Sumter City-County Planning Commission

SD-25-05 (Revision 1), 4865 Peach Orchard Rd. – Valley Ridge Subdivision (County)

Exhibit 1:
SD-25-05 – Valley Ridge (County)
Proposed Conditions of Approval

Exhibit 2:
SD-25-01 – Valley Ridge (County)
Outstanding Technical Review Items

Figure 3 –Proposed subdivision revisions

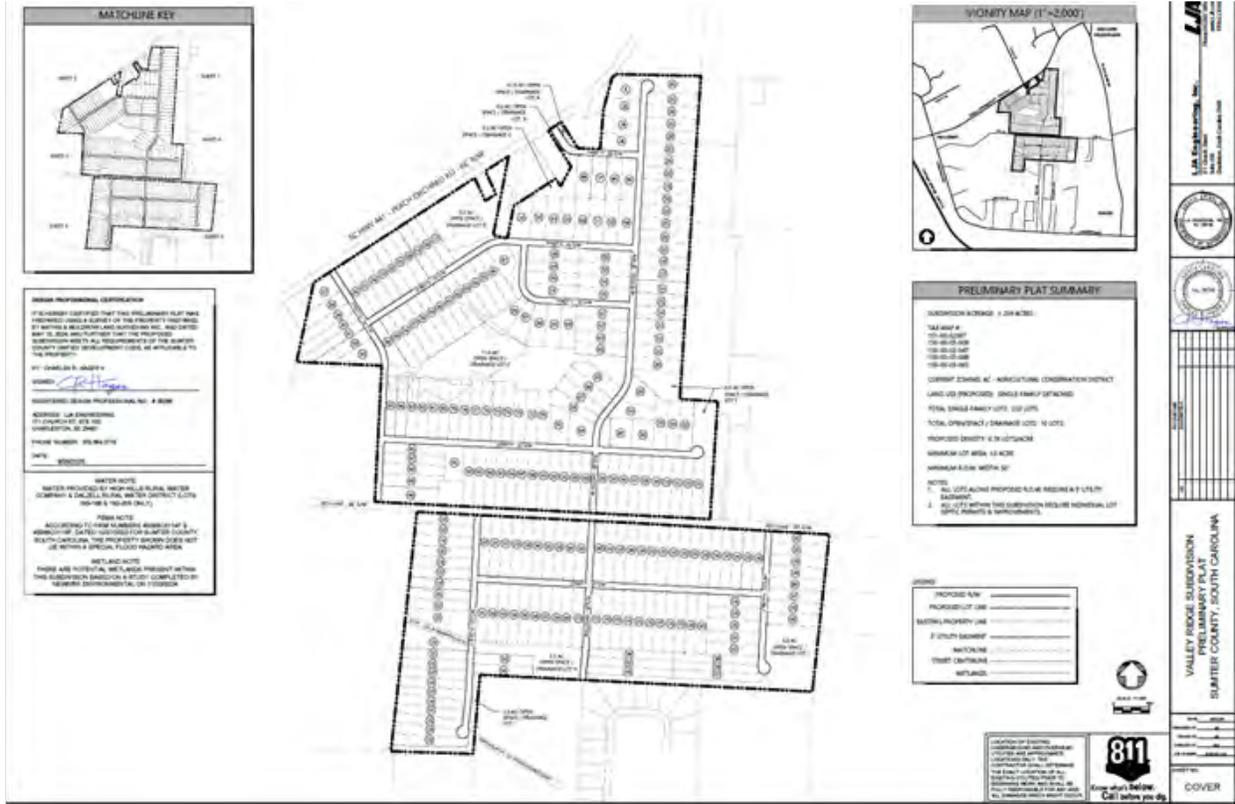
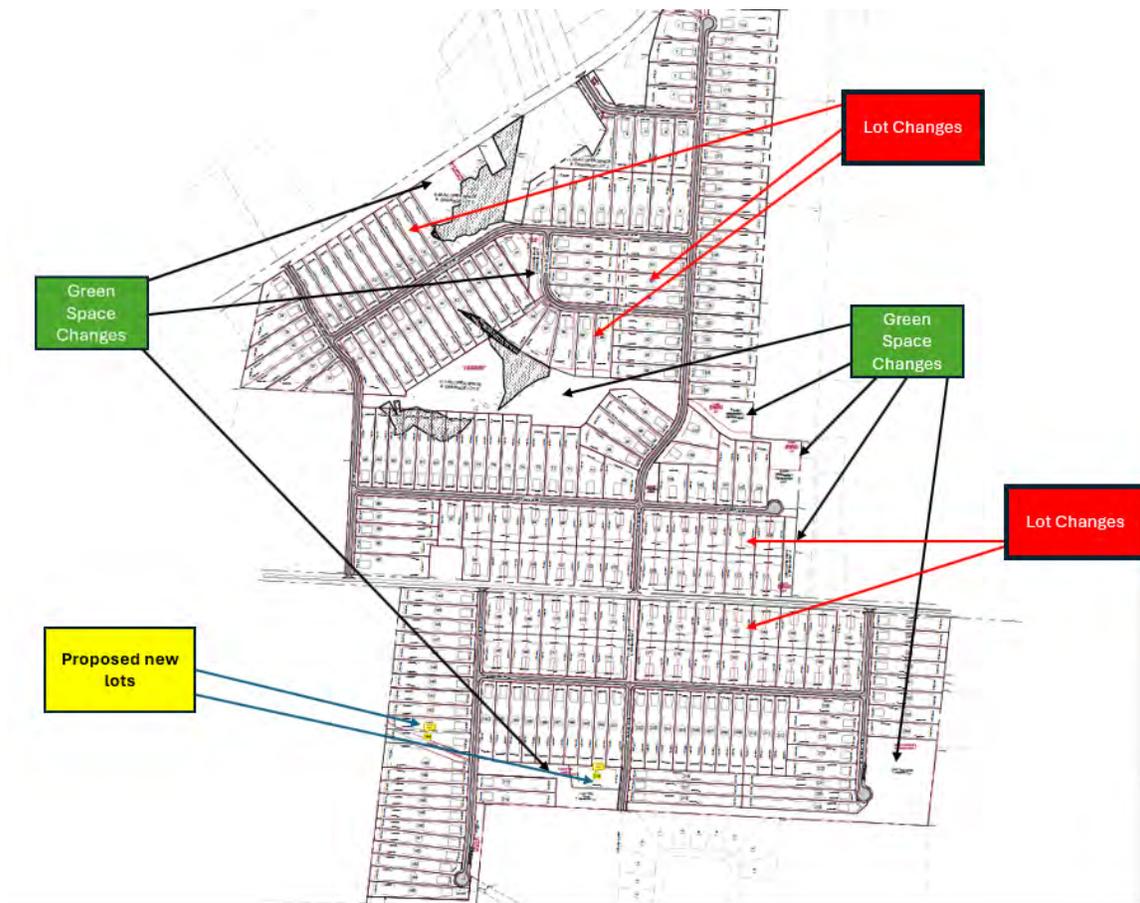
This resubmittal reflects revisions to the previously approved subdivision plan, including the addition of two residential lots, the expansion of designated green space areas, and the reconfiguration of several lot layouts within the development. The primary changes occur along Red Lane Road, where narrower lots have been reconfigured into wider lots to allow direct access to Red Lane Road. The updated plan also includes ten proposed road names for the subdivision.

VALLEY RIDGE SUBDIVISION
 RED-BLACK PRELIMINARY PLAT
 OVERLAY EXHIBIT
 EXHIBIT # 1 OF 1

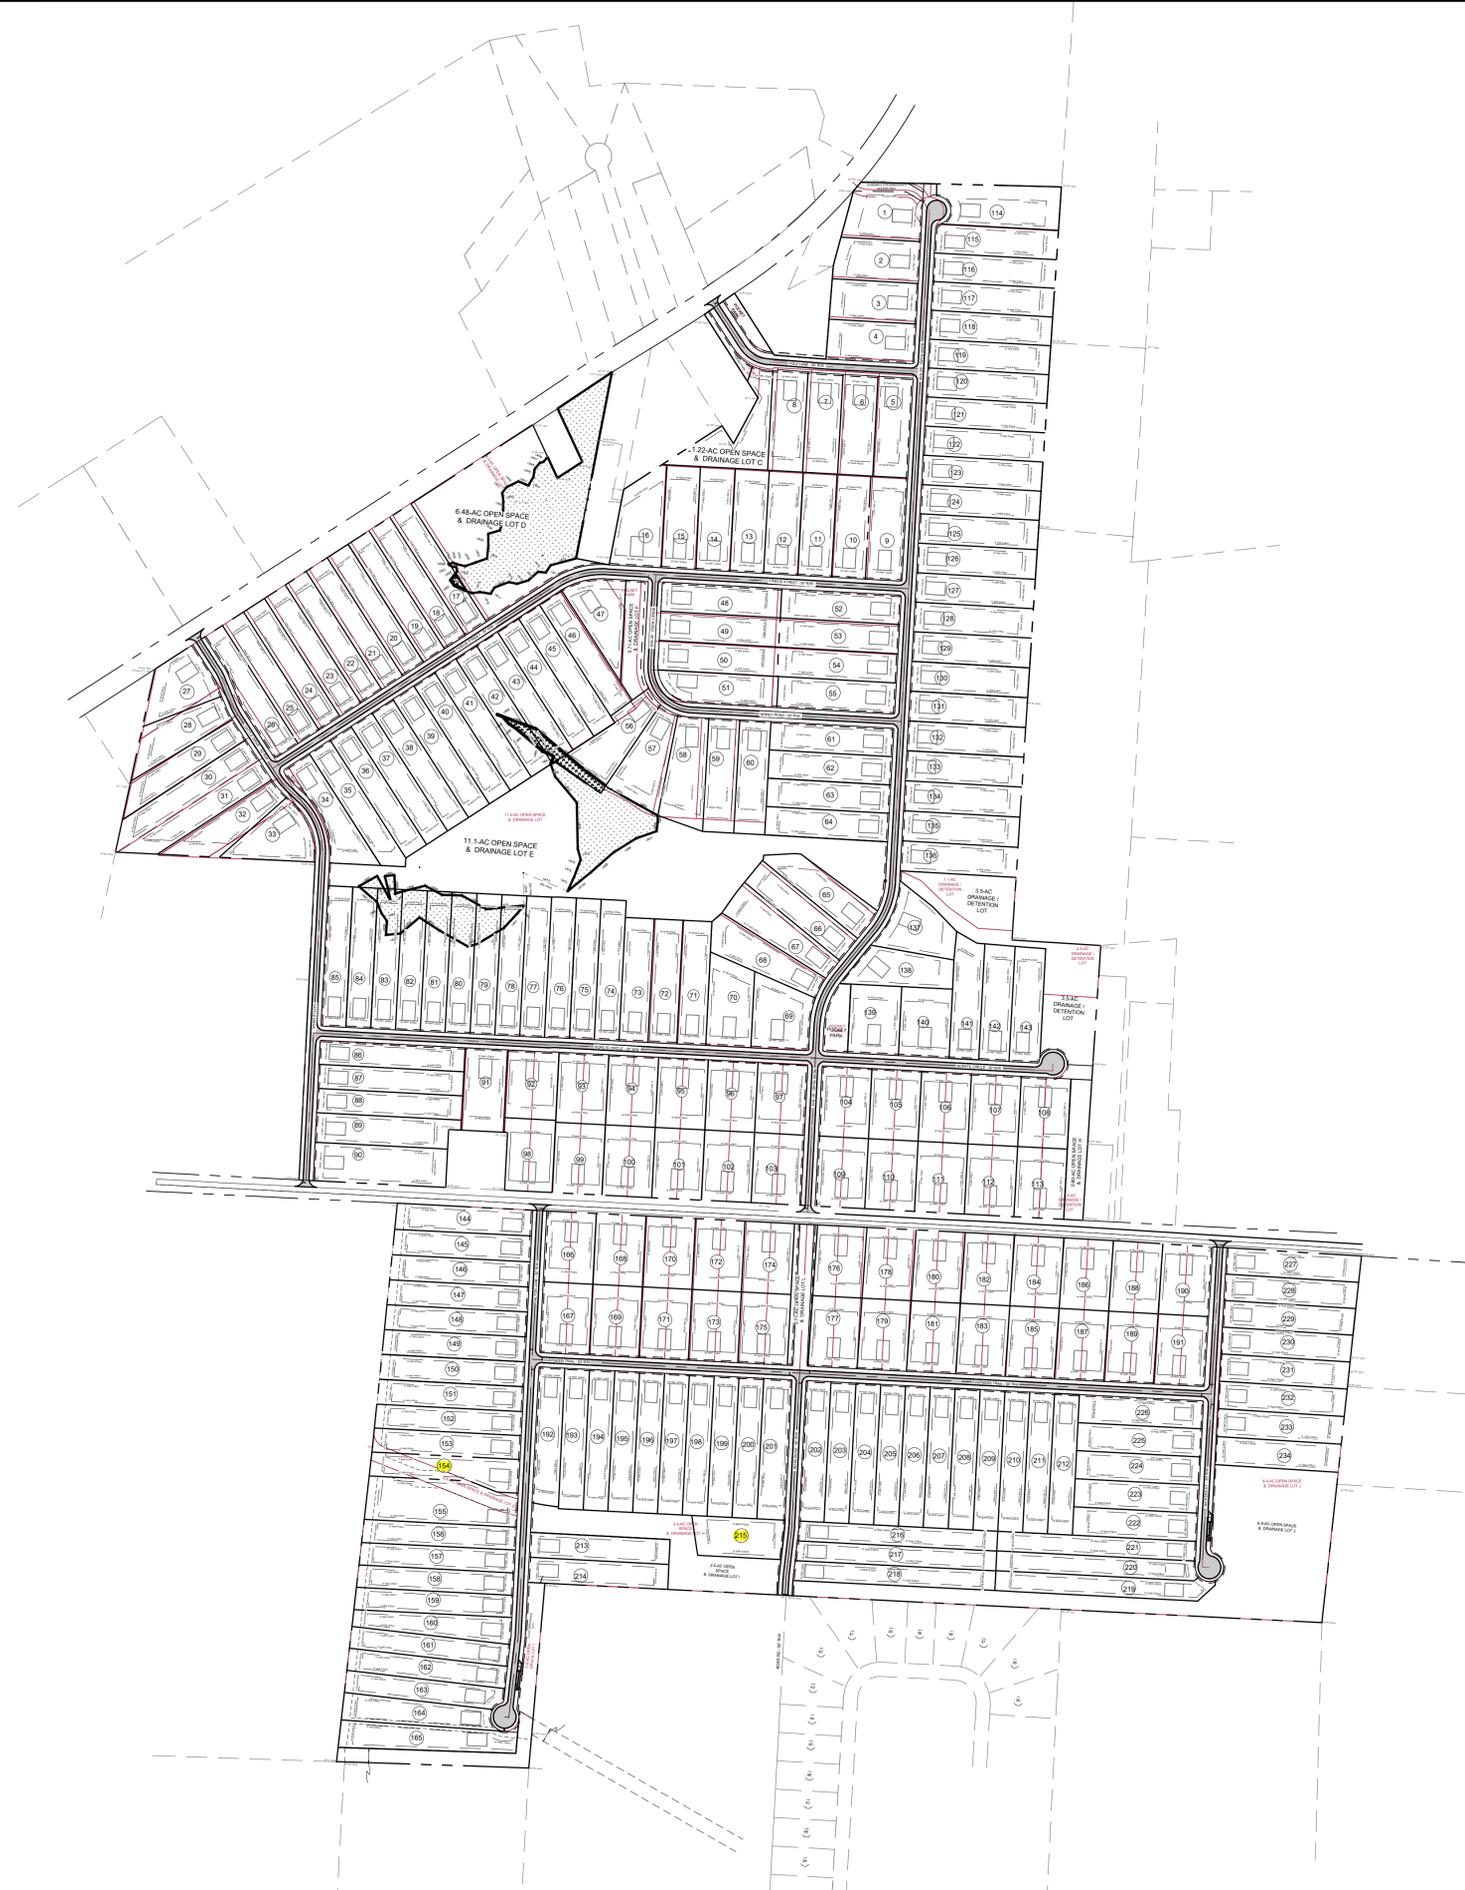
4. Please provide a tree survey verifying presence or absence of ‘significant’ (10-29” DBH) or ‘historic’ (30”+ DBH) trees. If removal of any significant or historic trees is planned, please provide a mitigation plan to offset the removal.
5. Please provide a landscaping plan for property buffers where a less intensive use is in place, as well as entrance landscaping plans in accordance with Article 8.
